LAND DEVELOPMENT SERVICES
March 6, 2018 – Amended April 5, 2018

STAFF REPORT

Proposed Amendments to *The Code of the County of Fairfax, Virginia* (Code) and to the Public Facilities Manual (PFM) related to Interpretation of the PFM, Hydraulic Grade Lines, Debris Control Devices, New Fees for Modifications and Appeals, and Other Edits

PLATE NO.	STD. NO.
61A-6

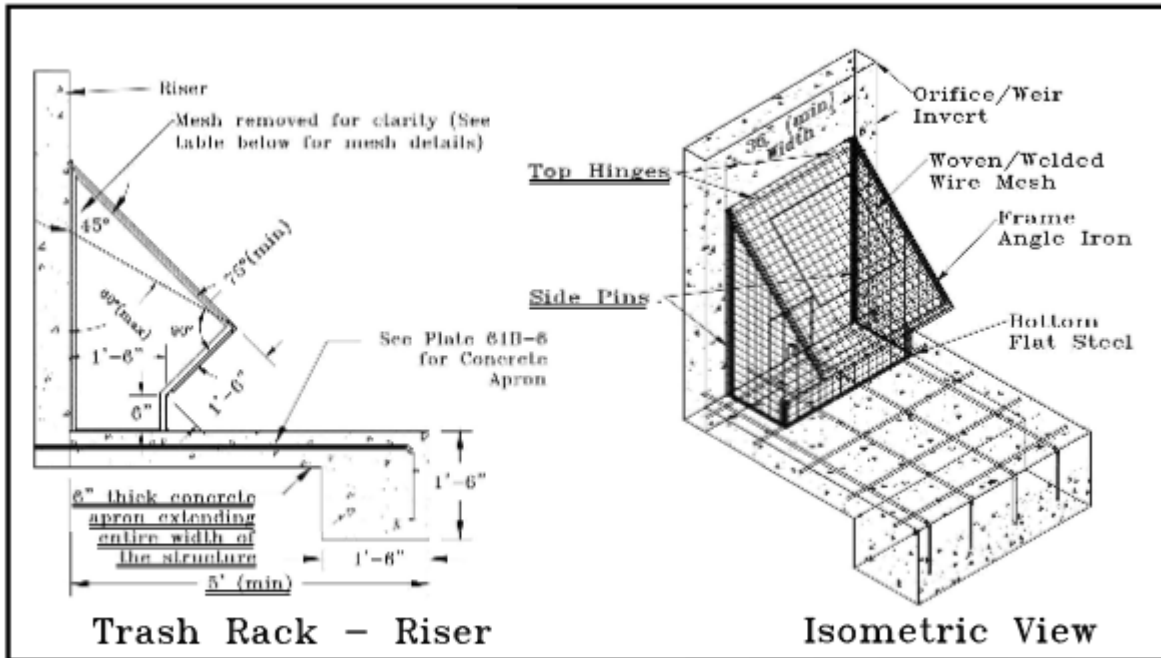
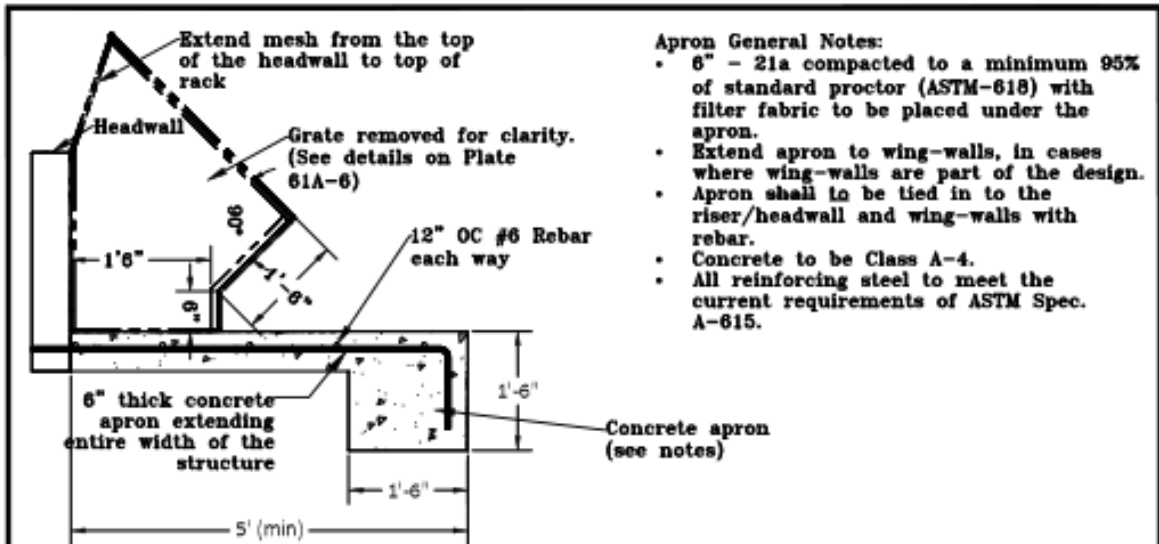
233 **Amend Chapter 6, to delete existing Plate 61-6 (BMP Extended Drawdown Device**
234 **(Example Detail), and add Plates 61A-6 (Low Flow/BMP Drawdown Device) and 61B-6**
235 **(Low Flow/BMP Drawdown Device (Mounting Details), to read as follows:**

209
210 6-1604.8B Debris control devices for dry stormwater management ponds are ~~may be~~ required for
211 low level intakes ~~at the pond bottom.~~ that are less than 15 inches in diameter or equivalent size
212 opening, and may be required for other opening sizes in accordance with §6-1604.8. The
213 preferred debris control structure is shown in Plates 61A-6 and 61B-6. In these situations, debris
214 control structures such as those discussed in the FHWA publication entitled “Debris Control
215 Structures (HEC No. 9)” should be considered where appropriate.

216
217 6-1604.8C Debris control devices for extended dry stormwater management facilities are
218 required for the low flow orifice controlling the extended drawdown period. The preferred trash
219 rack detail for those facilities is shown in Plates ~~61-6~~ 61A-6 and 61B-6.
